PROJECT MSXII_DC-DC_Converter.PrjPcb		<div><div>MIDNIGHT</div><div></div><div>SUN</div></div> <div>Engineering 5 - 1002 University of Waterloo (519) 888-4567 x32978 hardware@uwmidsun.com</div>
DOCUMENT *		
PART NUMBER	VARIANT [No Variations]	
DRAWN BY Aashmika Mali	REVISION 2.0	
LAST MODIFIED 2019-09-05	SHEET * OF *

# Board Slack Report

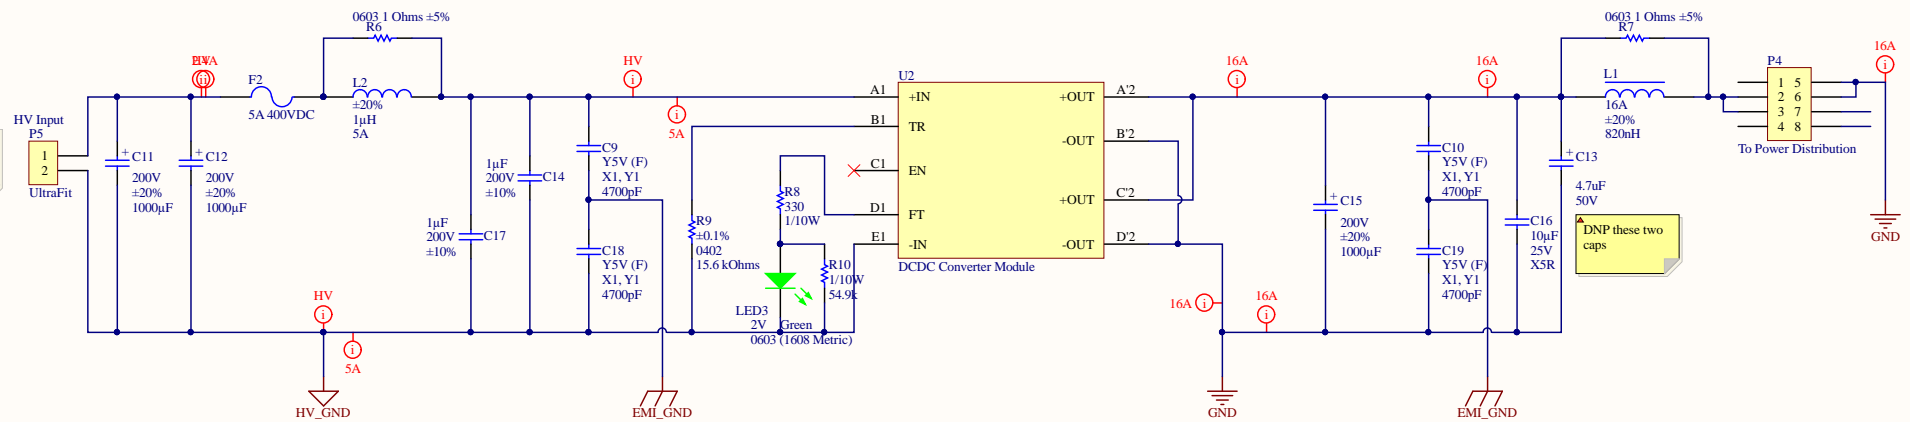
used this to find r-trim  
<http://spicewebprd.vicorpower.com/apps/dcmTrimCalculator/Calculator.php>  
analysis also said that it would be 2.4A drawn on HV side

Swap this connector with 7460719
